SERVICE PROCEDURE

SUBJECT: SAFETY RECALL Rear Axle Spring Wedge Shim on certain 2023 International® HV™ Series trucks built 04/29/2022 thru 12/07/2022 and 2023 and 2024 International® MV™ Series trucks built 02/24/2022 thru 01/18/2023 with feature code 14VAD, 14VAG, or 14VAH (Suspension, rear, single with vari-rate springs)

VEHICLE RECALL 23505

Figure 1. Spring Wedge Shim Orientation

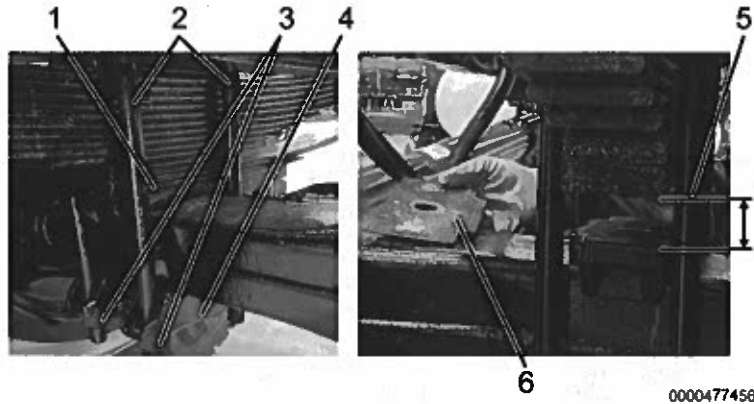
The rear axle spring wedge shim may have been installed in the incorrect orientation (180-degrees). An incorrectly oriented axle spring wedge shim can result in driveline angles out of specification and can cause premature wear and eventual failure of a U-joint, which could result in drive shaft separation from the vehicle. U-joint failure resulting in drive shaft separation from the vehicle can increase the risk of a vehicle crash that may result in property damage, personal injury, or death.

1. Incorrect spring wedge orientation (thin portion facing front)
 2. U-joint bolt (2)
 3. U-bolt nut / washer (4, 2 shown)
 4. Lower axle seat
 5. Gap between leaf spring and axle
 6. Spring shim / wedge shim
7. Starting on driver-side of vehicle, remove four U-bolt nuts and washers (Figure 1, Item 3), and lower axle seat (Figure 1, Item 4). Discard nuts and washers only.
 8. Lower jack to create a gap between leaf spring and axle (Figure 1, Item 5), to allow removal of spring wedge shim (Figure 1, Item 6).
 9. Remove spring wedge shim. If necessary, remove one U-bolt to allow removal of spring wedge shim.

Figure 2. Correct Wedge Shim Orientation

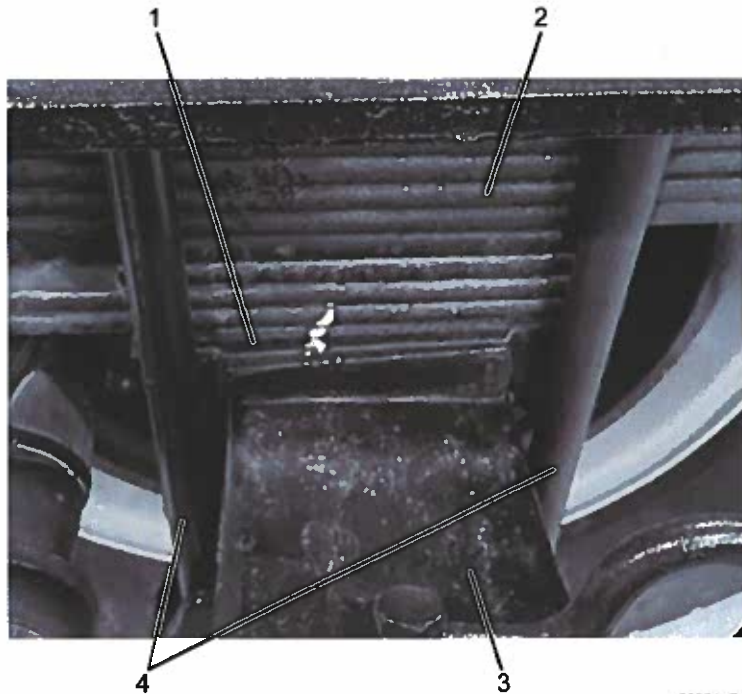
1. Correct orientation of spring wedge (thick portion towards front of vehicle)
2. Leaf spring
3. Axle
4. U-bolt (2)

10. Rotate spring wedge shim 180-degrees to orient thick portion of spring wedge shim towards front of vehicle (Figure 2, Item 1).
11. Reinstall spring wedge shim (Figure 2, Item 1) and if removed in Step 8, reinstall U-bolt (Figure 2, Item 4).
